Access Compliance Report

Public Rights-of-Way

Intersection ID: 23332	Main Street: HOPETON_RD	Cross Street: SHARON_RD_WEST	Location: NW
ADA ID: 02222E5912F0	Ramp Type: PerpDiag	Initial Pass/Fail: Fail	Overall Compliance: No
			Severity Score: 13.75

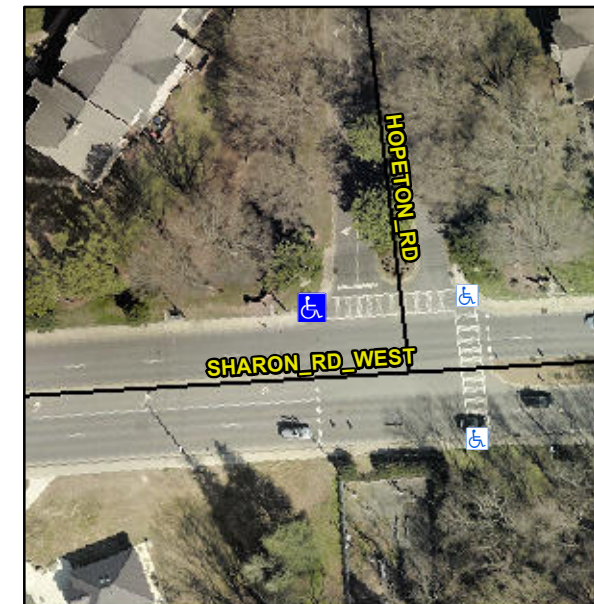
Not Found, R304.2.2, R304.5.3

Compliance	Description	Data	Compliance	Description	Data
N/A	Ramp Length (in)	60.0	No	Ramp Slope (%)	9.6
Yes	Ramp Width (in)	48.0	No	Ramp XSlope (%)	4.9
N/A	Flare Type LT	N/A	N/A	Flare Type RT	N/A
N/A	Flare Slope LT (%)	N/A	N/A	Flare Slope RT (%)	N/A
N/A	Flare Traversable LT?	N/A	N/A	Flare Traversable RT?	N/A
N/A	Landing Length (in)	N/A	N/A	DWS Provided?	N/A
N/A	Landing Width (in)	N/A	N/A	DWS Contrast?	N/A
N/A	Landing Slope (%)	N/A	N/A	DWS Length (in)	N/A
N/A	Landing X Slope (%)	N/A	N/A	DWS Full Width?	N/A
N/A	Landing Curb? (Y/N)	N/A	N/A	DWS Offset (in)	N/A
N/A	Shared Landing?	N/A			
N/A	Gutter Ponding?	N/A	N/A	Gutter Slope (%)	N/A
N/A	Gutter Lip Ht (in)	N/A	N/A	Gutter X Slope (%)	N/A
N/A	Painted X Walk1?	No	N/A	Painted X Walk2?	Yes
	X Walk 1 Direction	To S		X Walk 2 Direction	To E
N/A	X Walk 1 Width (in)	N/A	N/A	X Walk 2 Width (in)	121.0
	X Walk 1 Slope (%)	5.0		X Walk 2 Slope (%)	1.1
	X Walk 1 X Slope (%)	1.6		X Walk 2 X Slope (%)	2.9

Remove & Replace Curb Ramp With Two New Directional Ramps or Equivalent.
